T.I. no.: 2021 - 24 Updated: -	Topic: New brewer motor bracket (New kit)
---	--

Date: 30.08.2021	Priority	Need for action
Affected machines: SCS / SOUL	High	As soon as possible
From serial number: -	Medium	On next visit to the machine
As of date: -	x Low	x FYI only

ADVICE FOR TECHNICIANS

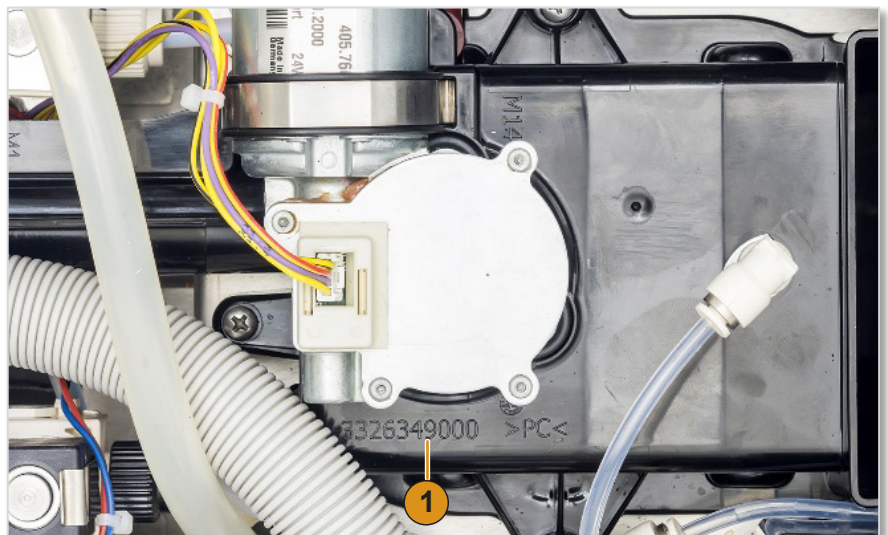
If the brewing motor detaches, the insulating hose can 065259 be used for repair.

BREWER MOTOR FIXATION

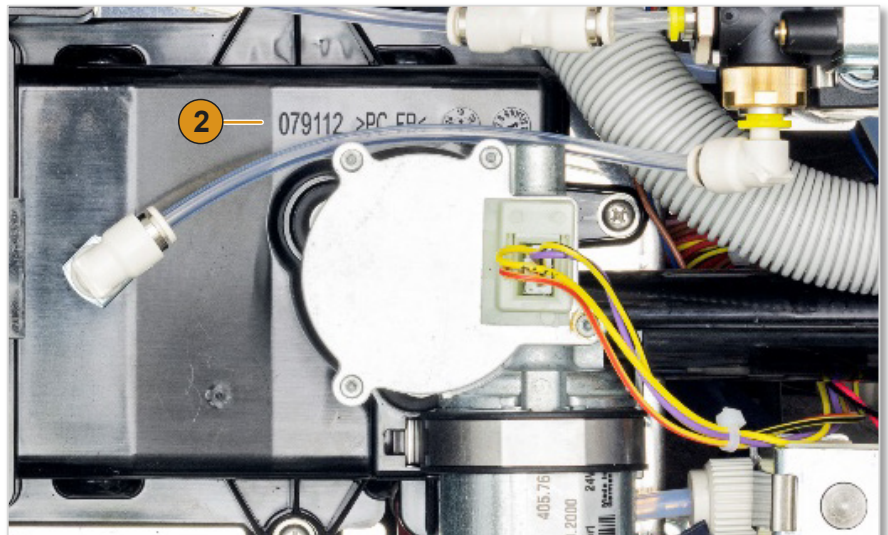
From CW03/2020 a new brewer motor bracket has been introduced:

For recognition see article number on the polycarbonate part:

- Previous article number (1)
- New article number (2).

Until ±CW52/2019: 33.2634.9000 > reworked to 079742 for use in the Soul

The new bracket 079112 has the following advantages:

- Substantially stronger reinforcements around the motor.
- Brewer motor can be removed (from the top) while the bracket remains in place.

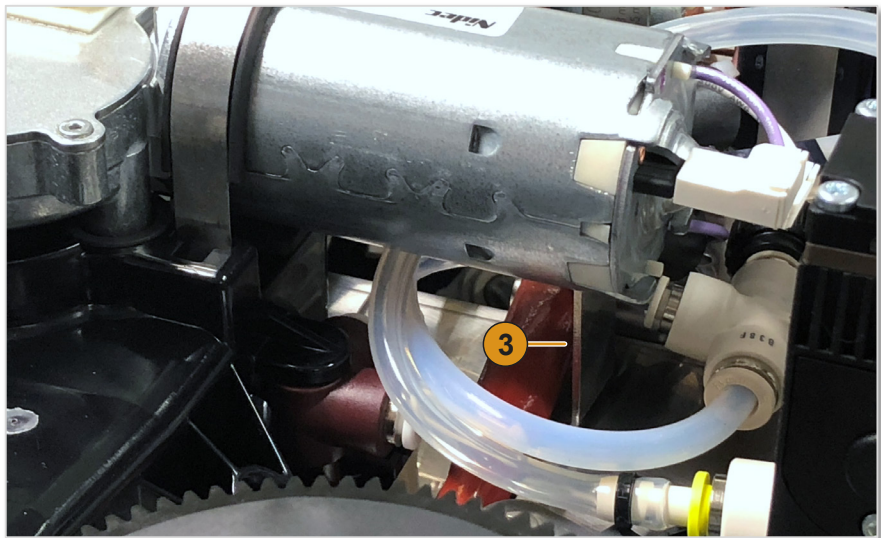
Currently a separate angled metal support is placed under the brewer motor (3).

Without this metal support it is possible that, when placing the brewer back into the machine, the motor is tilted making this process impossible.

Placement of isolation sleeve

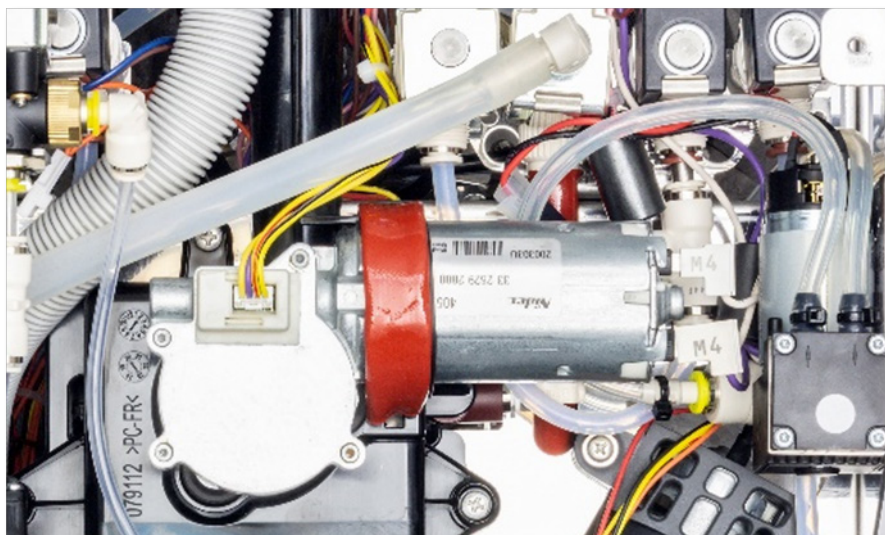
Between October 15, 2020 and November 2nd, 2020 an isolation sleeve has been placed over the metal clamp 33.2635.9000.

The Feedback from the field informed about the possibility that the fixation of the motor can become too loose over time.

This will result in the brewer motor to be pushed upwards while trying to place the brewing unit back after removal.

The issue can potentially happen with machines produced between Jan 13th, 2020 and Oct 14, 2020.

The solution is to place 110 mm of isolation sleeve 065259 over the metal clamp 33.2635.9000 as can be viewed in the picture. This solution has been implemented in the production of all machines from October 15th, 2020.

From approximately Nov 2nd, 2020, a modified brewer motor bracket was introduced in production resulting in enough tension on the spring without isolation sleeve.
